**San Diego Regional Water Quality Control Board**

**Subject: Notice of Violation and Investigative Order No. R9-2016-0067, Otay Landfill, San Diego County**

**NOTICE OF VIOLATION AND  
INVESTIGATION ORDER  
No. R9-2016-0067**

# Otay Landfill

Figure 5- Southwest Side Slope

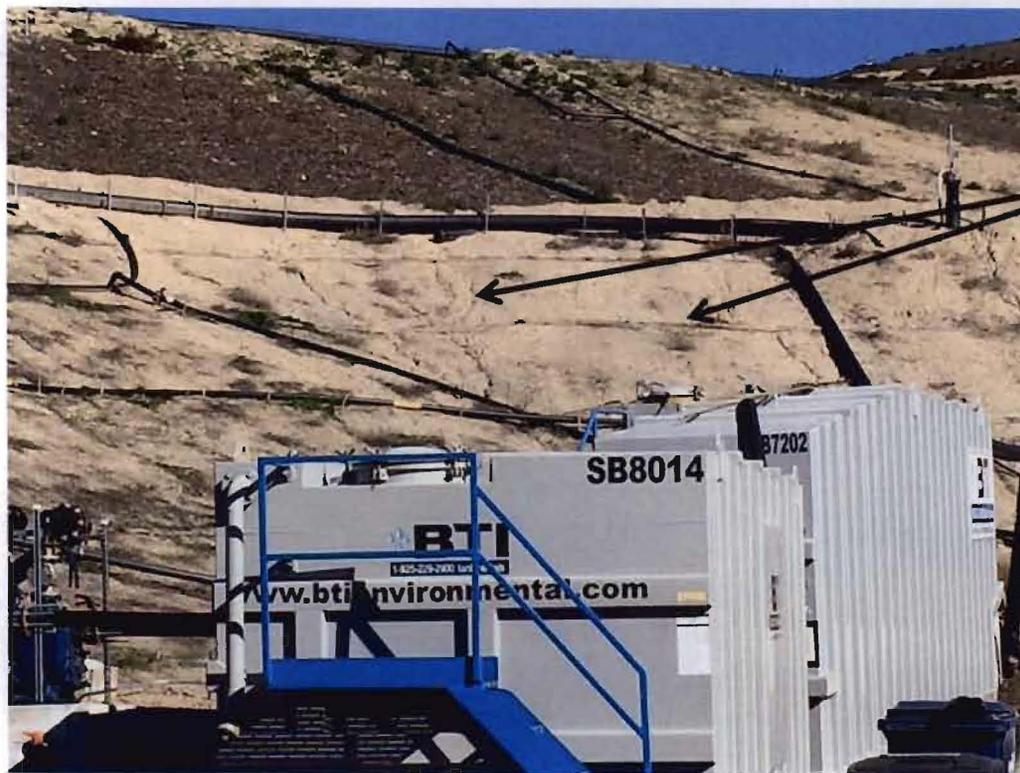
Failure to properly maintain the Site constitutes a violation of Order No. 90-09 Provision C.5, and IGP sections X.H.1 and X.H.1.e. Order No. 90-09 requires the Discharger to properly operate and maintain all facilities and systems of treatment and control which are installed or used by the Discharger to achieve compliance with the conditions of this Order. These include all storm water and surface water control systems used to prevent run-on and runoff, and to maintain positive drainage away from wastes, and all erosion control measures. During the November 13, 2014 and February 4, 2016 inspections, staff observed that the Discharger had failed to maintain best management practices (BMPs) to control or prevent erosion (Figures 4, 5 and 9).

1. Implement effective BMPs and storm water control systems to prevent erosion, manage and direct surface water flows, promote positive drainage, and prevent ponding, washout, and infiltration of surface water into wastes during the rainy season.
2. Implement effective stabilization for inactive areas, finished slopes, and other erodible areas prior to the next storm event.
3. Implement effective perimeter controls and stabilize all site entrances and exits to sufficiently control discharges of sediment from discharging offsite.
4. Implement measures to divert storm water run-on and runoff generated from within the landfill footprint, away from all erodible materials.
5. Implement measures to prevent leachate or wastewater runoff from the composting working surface from discharging into the East Storm Water Basin.

Figure from Anthony Torres, San Diego County LEA

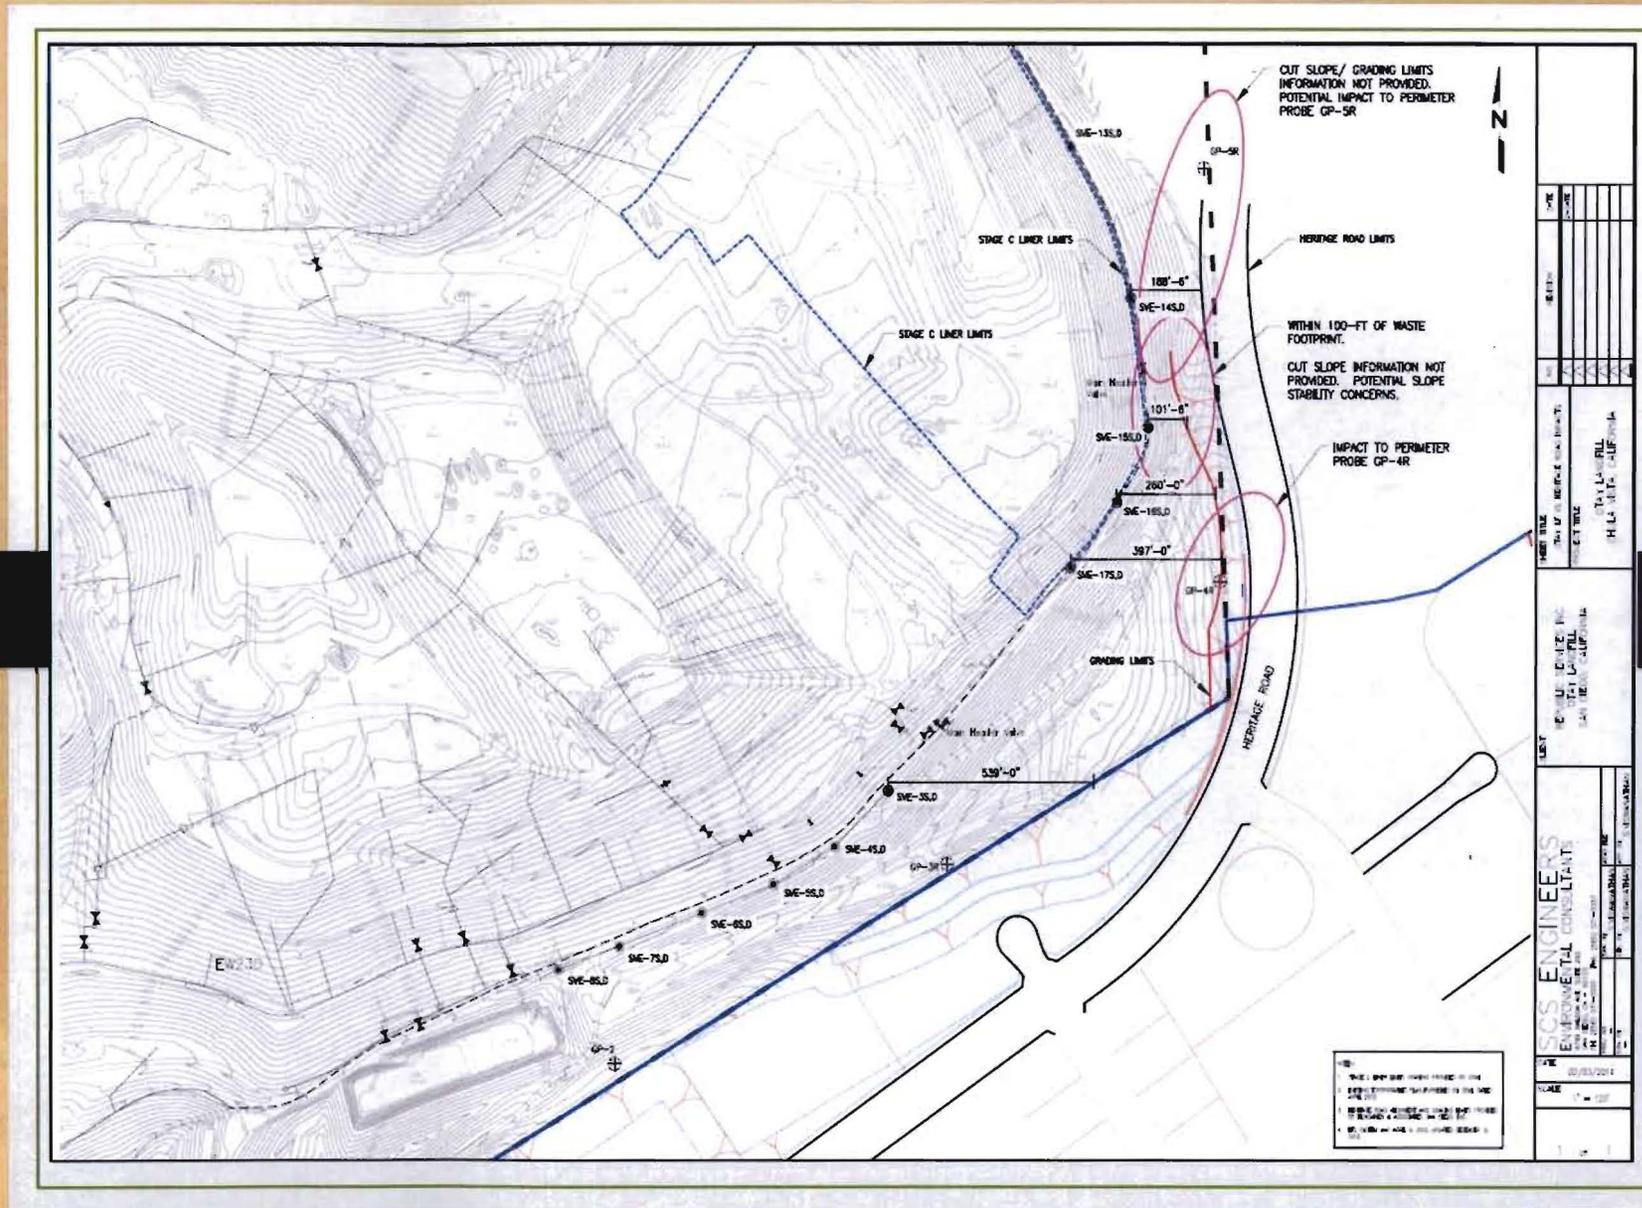
- Leachate production has significantly increased since 2011, and may currently be as high as 1 million gallons per month at the Otay Landfill.
- Leachate levels have risen in the waste fill along the southeast sideslope of Canyon 3 to an elevation where soil gas extraction wells are adversely affected by liquid levels and have been converted into leachate/liquid recovery wells<sup>1</sup> within the waste fill (Enclosure 1 – plot plan southeastern corner of Otay Landfill).

- ii. A second plot plan with the features required above but emphasizing footprint and waste fill slopes located adjacent to Heritage Road and the exterior southeast facing slopes located between the soil gas vapor probes SVE-85,D and SVE-13,D (see Enclosed Figure 1).

- a. the waste fill southeast facing slopes located between soil gas vapor probes SVE-85,D and SVE-13,D; and
- b. the exterior southeast facing natural slopes located between soil gas vapor probes SVE-85,D and SVE-13,D; and
- c. the toe of the slope behind SVE-85,D and SVE-13, D where Baldwin Home-Fed has a cut for the construction of Heritage Road.

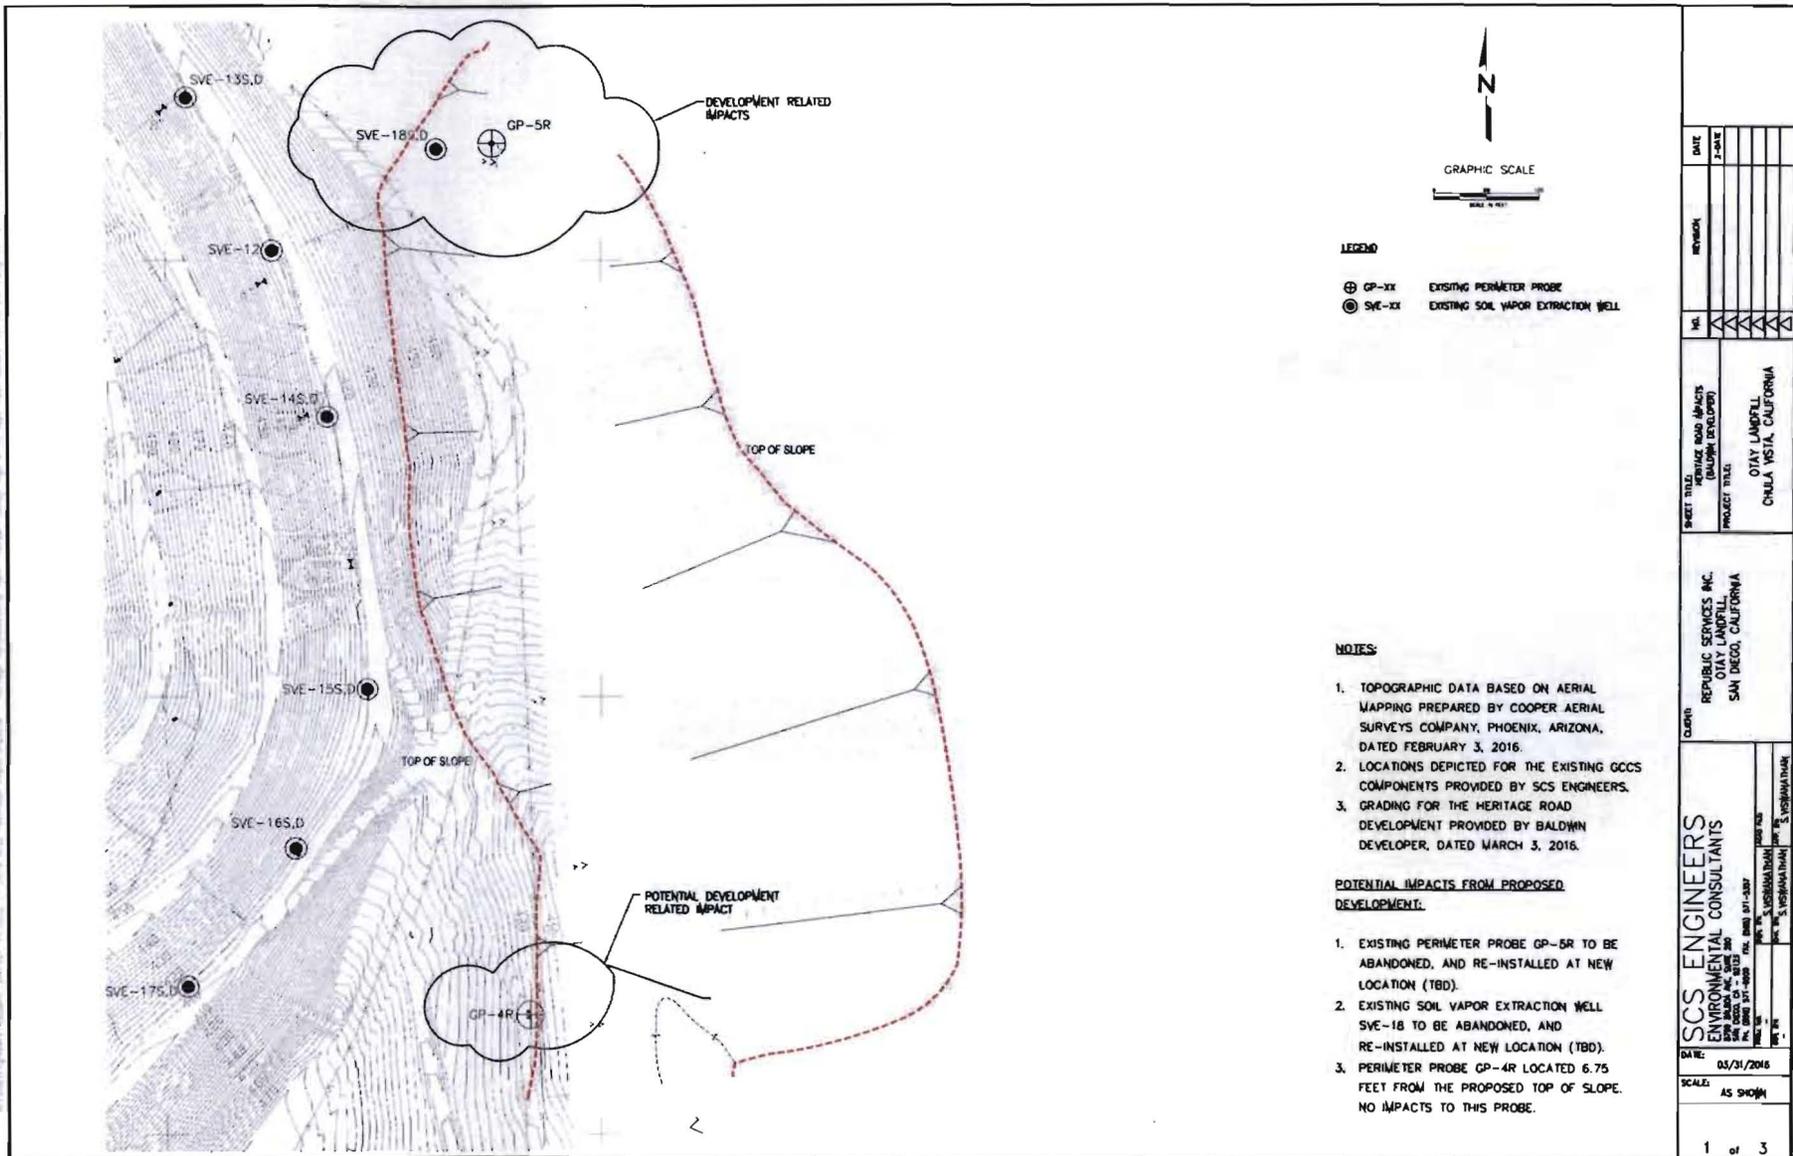
- The LEA met with Republic Services to discuss the removal and relocation of perimeter soil vapor probes GP-5R and SVE-18D.
- The reason for removal and relocation of the landfill gas probes was their location within an easement controlled by Baldwin Home-Fed, the Developer for Otay Villages I and II, a residential development located outside the southeast perimeter of the Canyon 3 Unit at the Otay Landfill.
- The Developer reportedly plans to further develop Heritage Road by cutting and grading the basal area of the slope supporting the southeast waste fill slope located along the southeast perimeter of the Canyon 3 area of Otay Landfill (Enclosure 2 – extent of planned grading and removal of soil vapor probes GP-5R and SVE-18D).

1. EXISTING PERIMETER PROBE GP-5R TO BE ABANDONED, AND RE-INSTALLED AT NEW LOCATION (TBD).
2. EXISTING SOIL VAPOR EXTRACTION WELL SVE-18 TO BE ABANDONED, AND RE-INSTALLED AT NEW LOCATION (TBD).
3. PERIMETER PROBE GP-4R LOCATED 6.75 FEET FROM THE PROPOSED TOP OF SLOPE. NO IMPACTS TO THIS PROBE.
